Proposal for Supplement 1 to the 05 series of amendments to UN Regulation No. 46 (Devices for indirect vision)

Submitted by the Working Party on General Safety Provisions*

The text reproduced below was adopted by the Working Party on General Safety Provisions (GRSG) at its 126th session (ECE/TRANS/WP.29/GRSG/105, para. 9). It is based on GRSG-126-25-Rev.1. It is submitted to the World Forum for Harmonization of Vehicle Regulations (WP.29) and to the Administrative Committee (AC.1) for consideration at their March 2024 sessions.

- (i) Edge of the reflecting surface enclosed in a protective housing
(ii) Reflecting surface projects beyond the protective housing in a specific adjustment position
(iii) Edge of the reflecting surface not enclosed by the protective housing

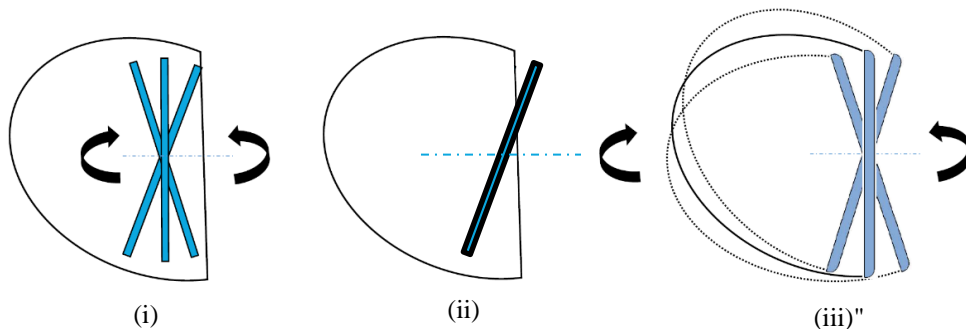
Paragraph 6.1.1.2., amend to read:

- "6.1.1.2. (a) Rear-view mirrors (Classes II to VII)

When the edge of the reflecting surface is enclosed in a protective housing, the radius of curvature 'c' on the housing's perimeter shall be not less than 2.5 mm at all points and in all directions, figure below (i).

When the reflecting surface projects beyond the protective housing in any adjustment position (figure below (ii)), the radius of curvature 'c' on the edge of the projecting part shall be not less than 2.5 mm and the reflecting surface shall return into the protective housing under a force of 50 N applied to the point of greatest projection, relative to the protective housing, in a horizontal direction, approximately parallel to the longitudinal median plane of the vehicle.

When the edge of the reflecting surface is not enclosed by the protective housing independent from any adjustment position, the radius of curvature 'c' on its perimeter shall be not less than 2.5 mm at all points and in all directions and shall apply to the edge of the projecting part, figure below (iii).

"Figure 9.1

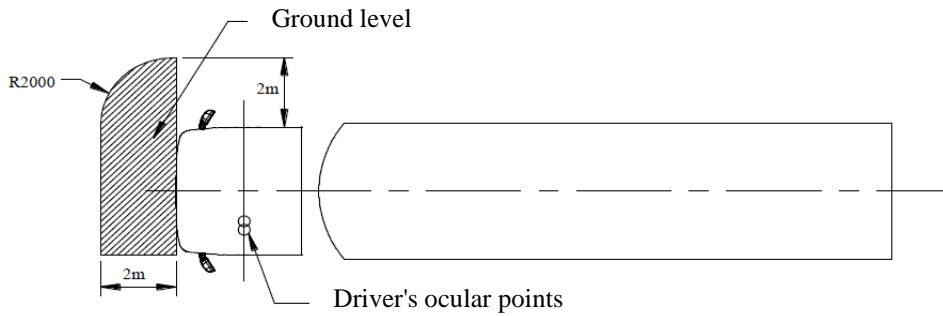
"15.2.4.6.1. The field of vision shall be such that the driver can see at least a flat horizontal portion of the road, which is for side-steered vehicles bounded by:

- (a) A transverse vertical plane through the outermost point of the front of the vehicle;
- (b) a transverse vertical plane 2,000 mm in front of the plane defined in (a);
- (c) a longitudinal vertical plane parallel to the longitudinal vertical median plane going through the outermost side of the vehicle at the driver's side;
- (d) a longitudinal vertical plane parallel to the longitudinal vertical median plane 2,000 mm outside the outermost side of the vehicle opposite to the driver's side; and
- (e) the front of this field of vision opposite to the driver's side may be rounded off with a radius of 2,000 mm (see Figure 9.1).

Figure 9, renumber as Figure 9.1. and amend to read:

"Figure 9.2
Class VI field of vision for centre-steered vehicle"

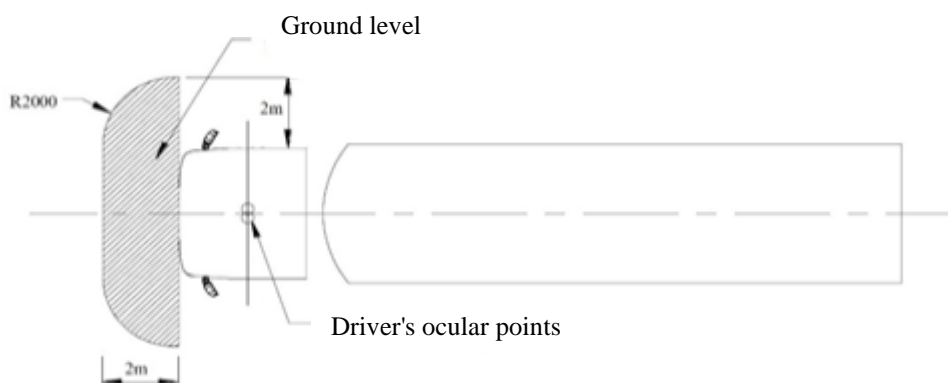
The field of vision shall be such that the driver can see at least a flat horizontal portion of the road, which is for centre-steered vehicles bounded by:

- (g) a transverse vertical plane 2,000 mm in front of the plane defined in (a);
- (h) a longitudinal vertical plane parallel to the longitudinal vertical median plane 2,000 mm outside the outermost side of both sides of the vehicle; and
- (i) the front of this field of vision on both sides may be rounded off with a radius of 2,000 mm (see Figure 9.2).

Insert a new figure 9.2., to read:
